Grading Plan Approved
as shown and/or noted
THOMAS P. GILLES, P.E.
Lake County Engineer

HSM BUILDERS
Windjammer Bay Sub. Phase 2
Site Plan For Sublot 60

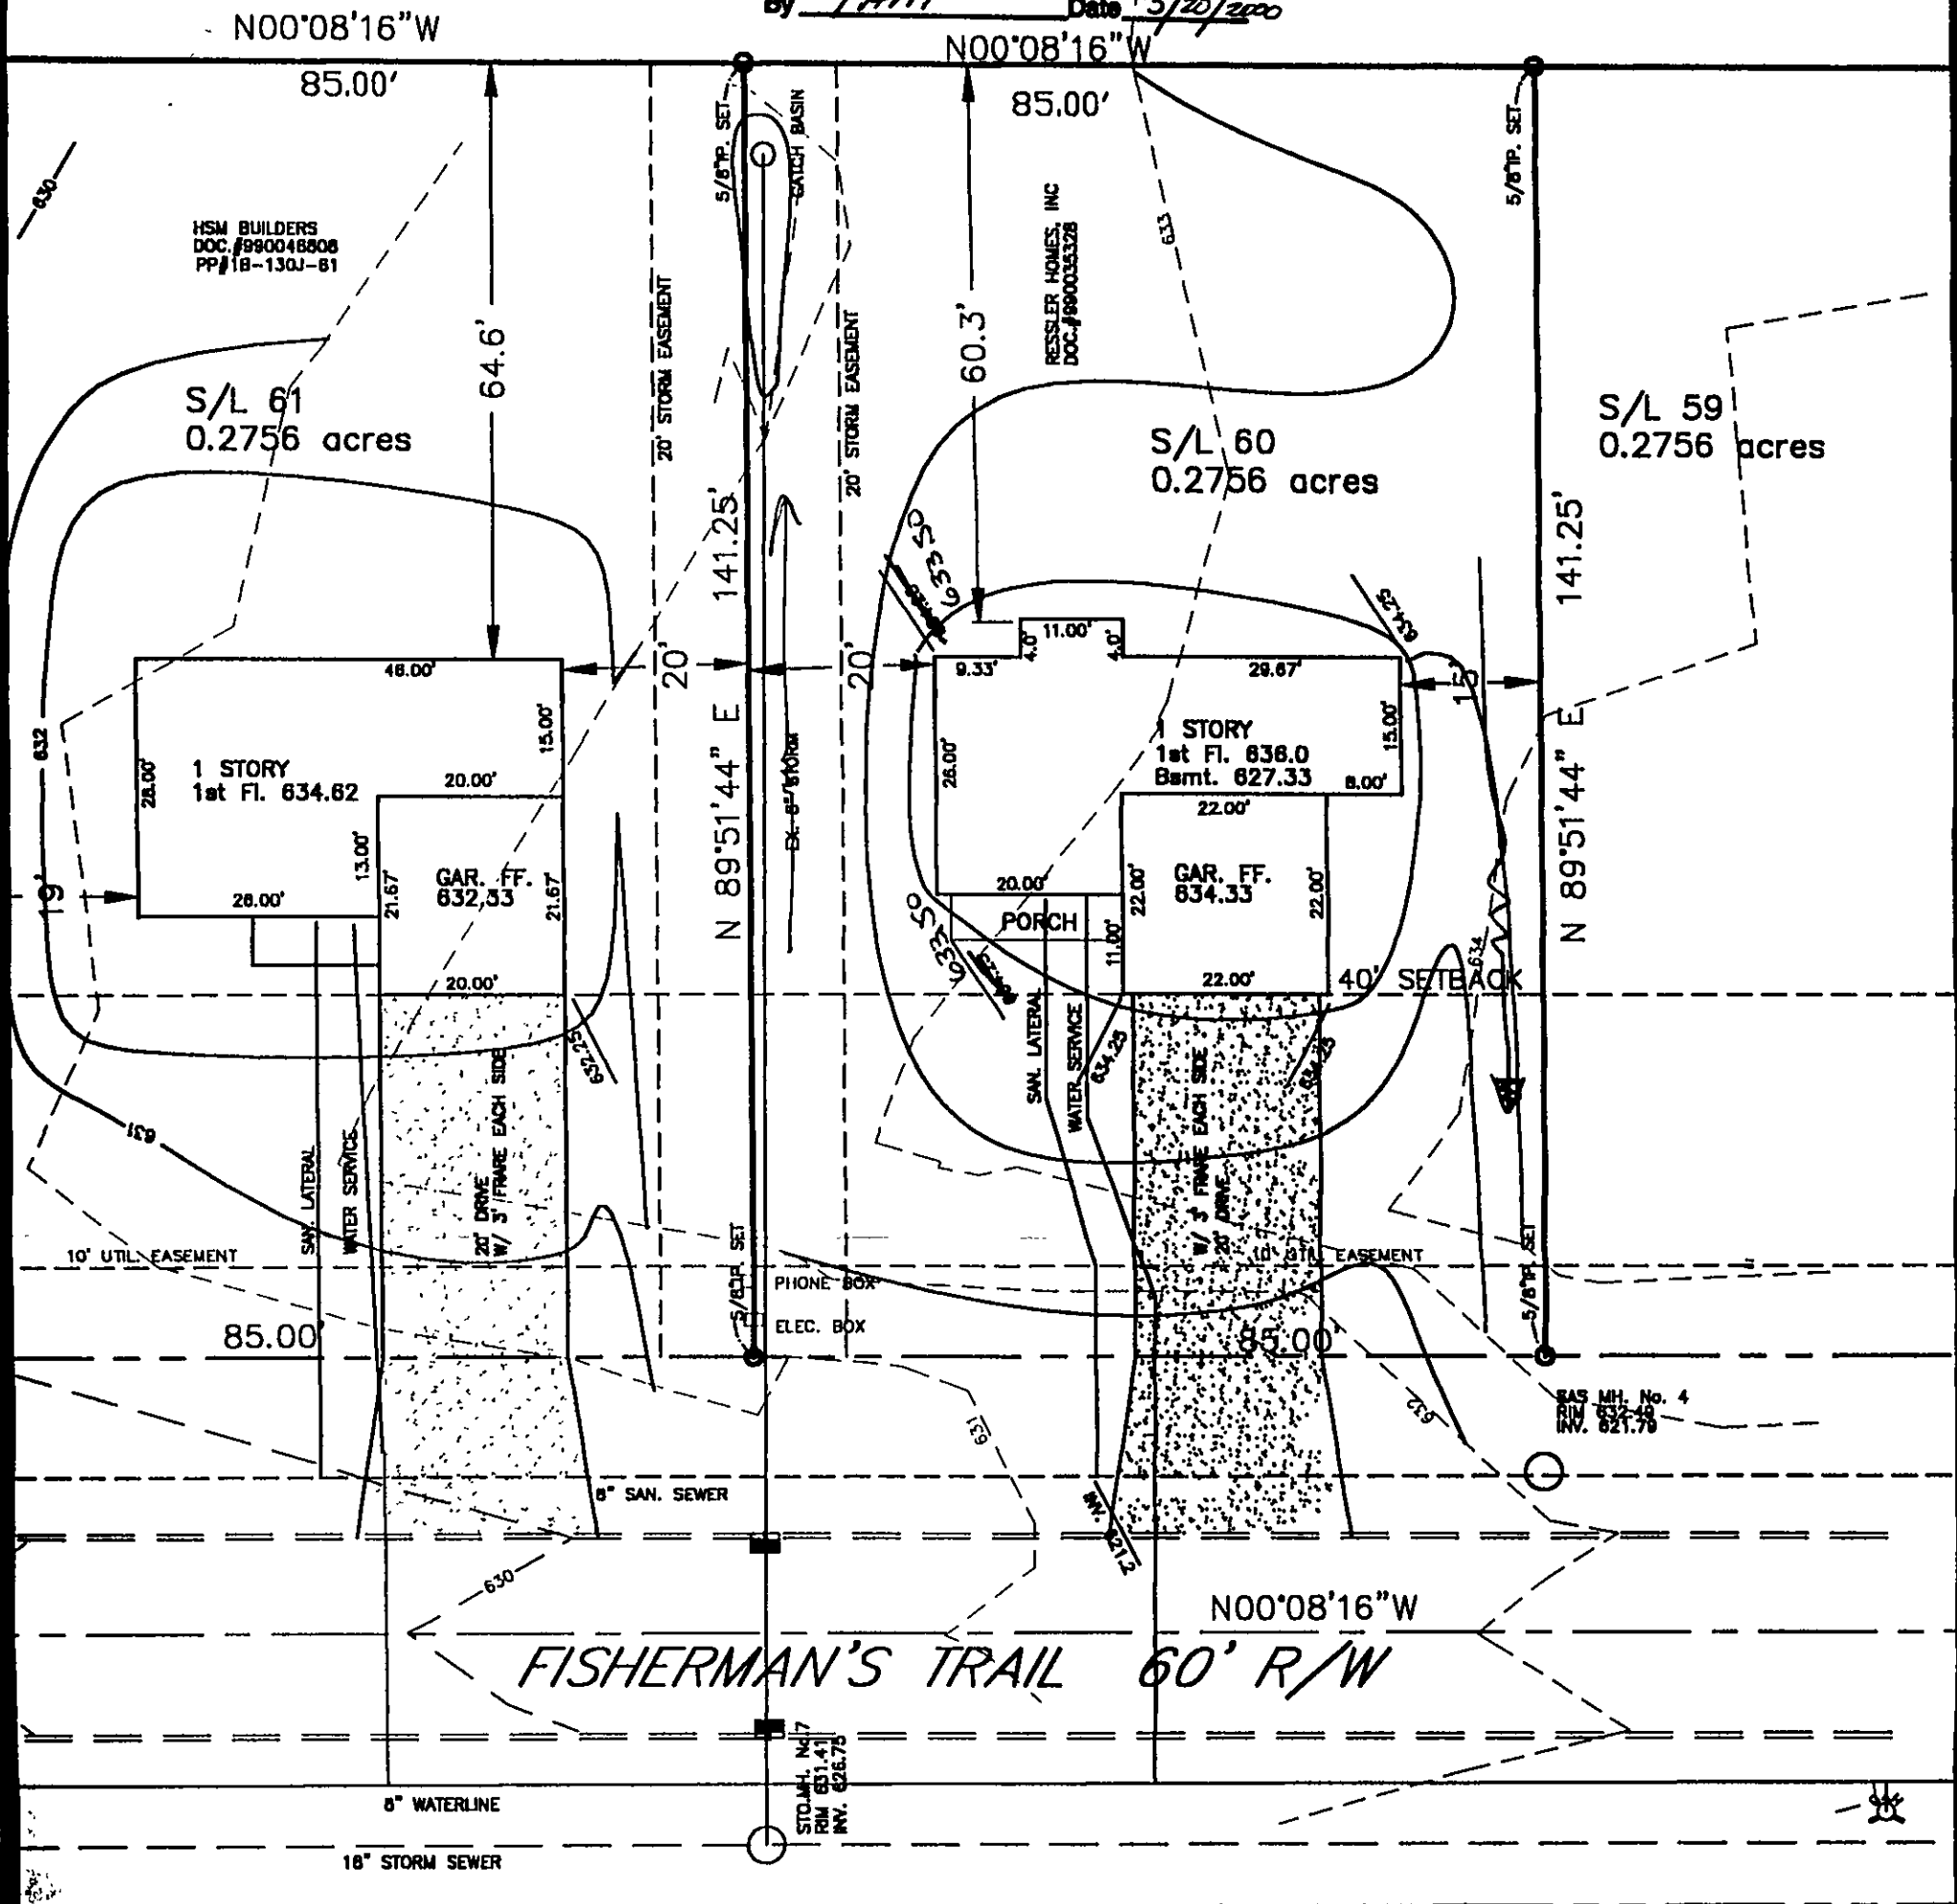
1. Scale as shown
2. Lower Fl. as noted
3. An ESC plan may be
required from LGSWCD

4. ROOF DRAINS
SHALL DISCHARGE
TO SPLASH BLOCKS
